(Work in Progress) QB Tailings & Water — Operational Process & Performance Measurement Architecture

Conceptual process boundaries, material and water flows, and associated operational reporting metrics.

PROPOSED REVISION — QB validation required

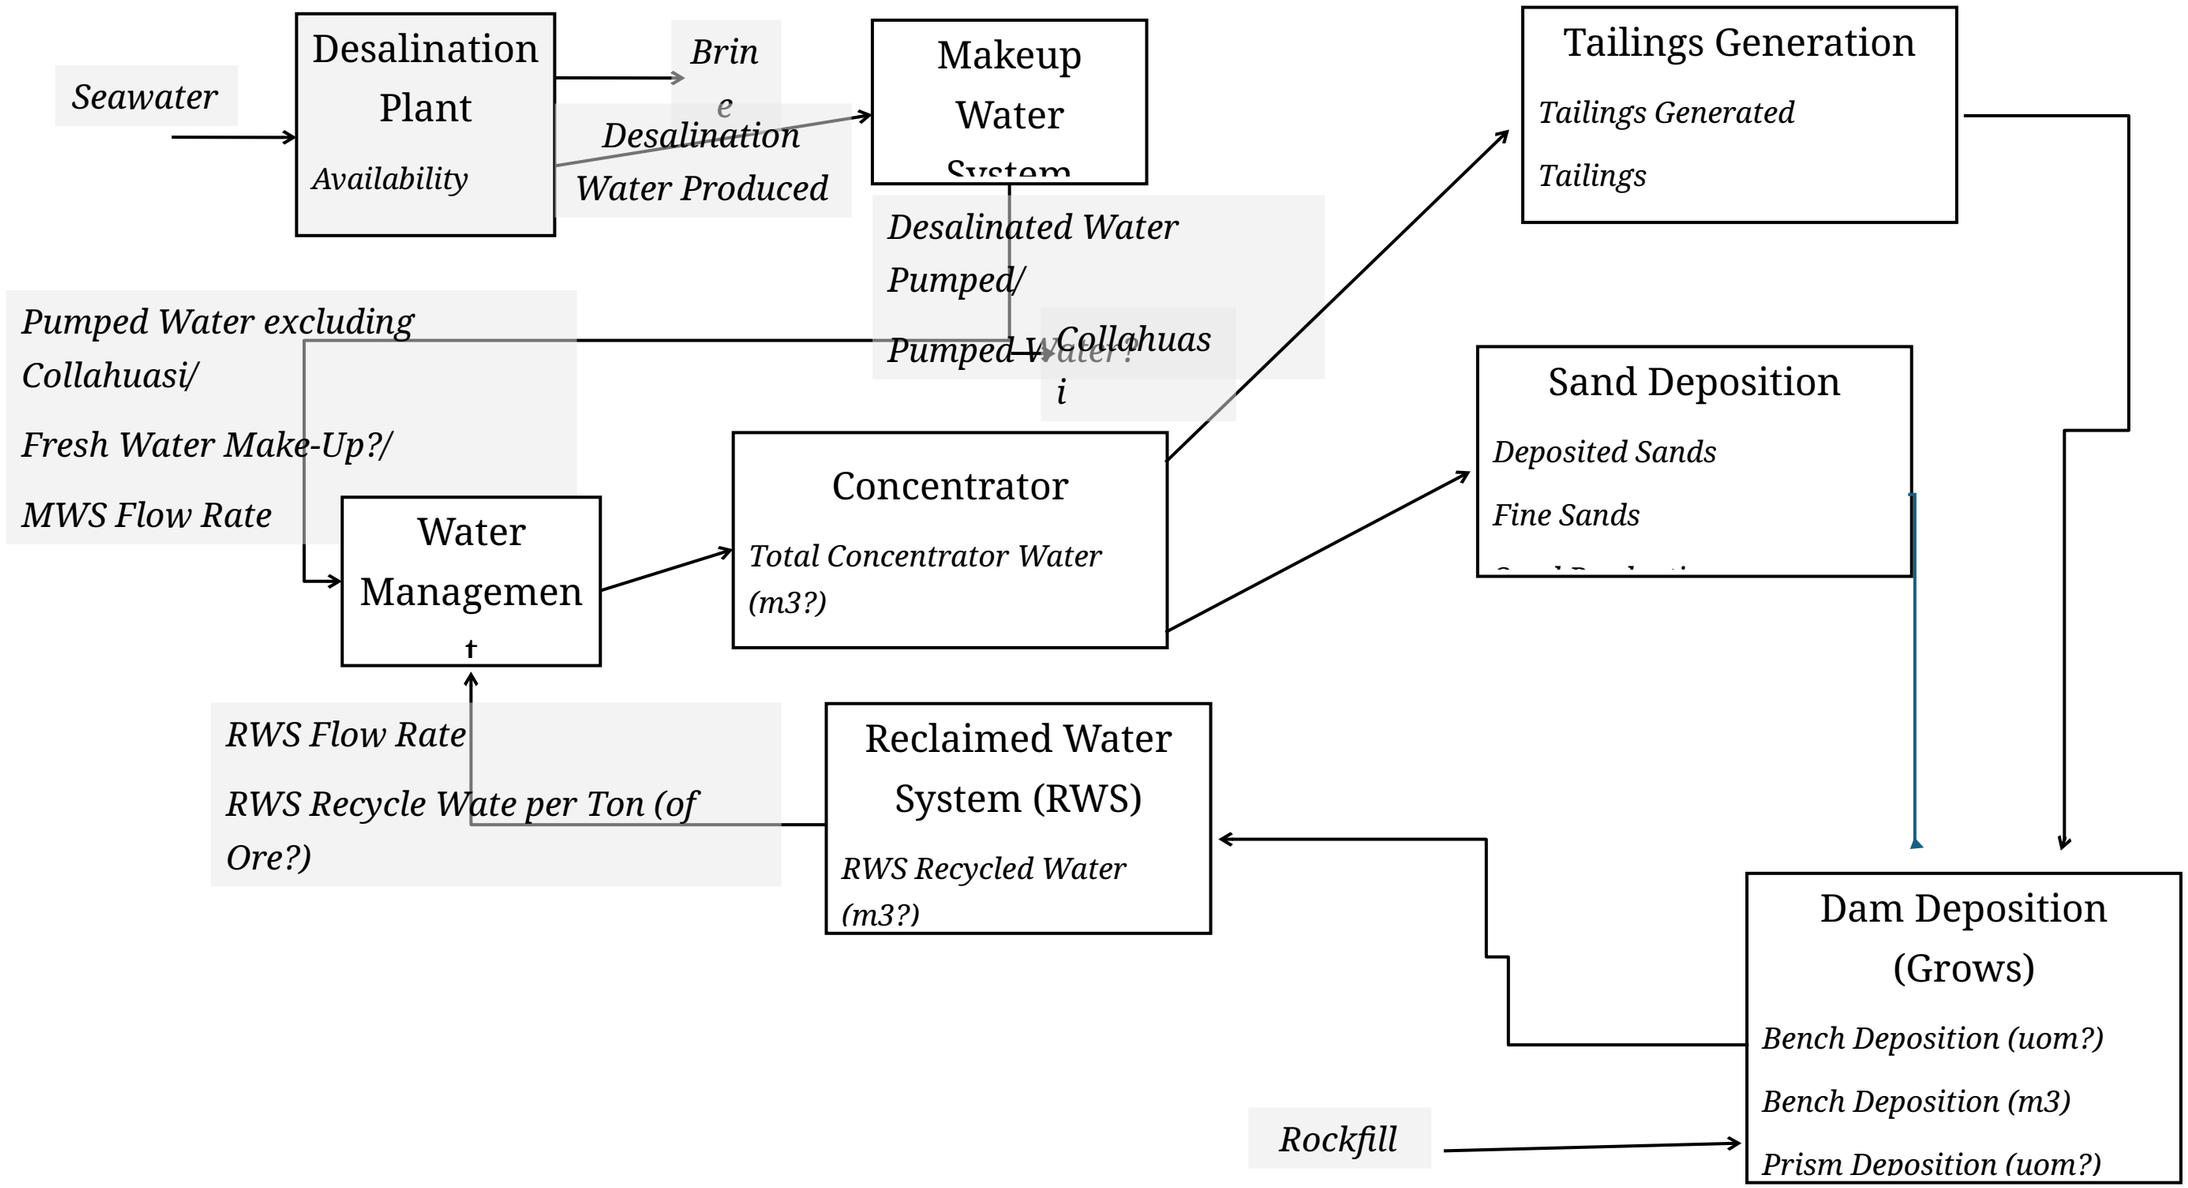
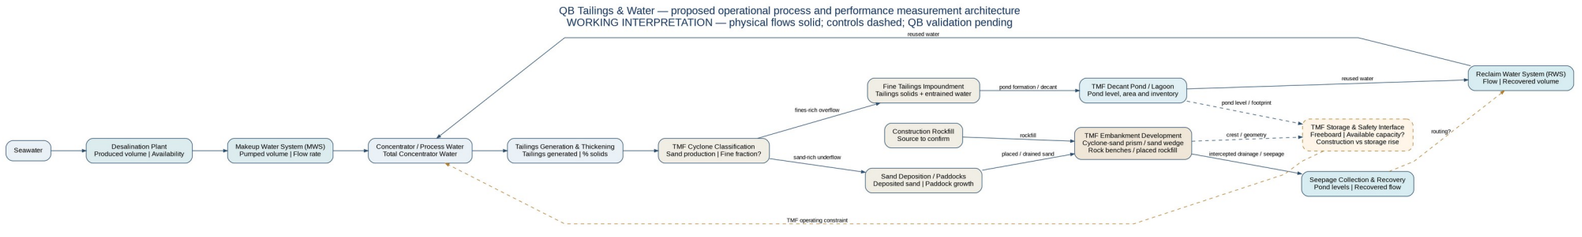
This second page is a proposed process and measurement map. The first page retains the original work-in-progress drawing. The sand-dam prism is treated as cyclone-sand construction (regional convention); rock benches and rockfill are separate construction inputs. Do not interpret the dashed seepage-to-RWS connection as verified plant routing.

Suggested high-level reporting: prioritize capacity constraint / safe operating margin and construction progress to plan. Retain bench, prism, paddock, lagoon and geotechnical details at site technical level unless exceptions materially affect operations. Source: Teck QB TMF disclosure, Teck QB action plan, SERNAGEOMIN operating guide; verify with QB.
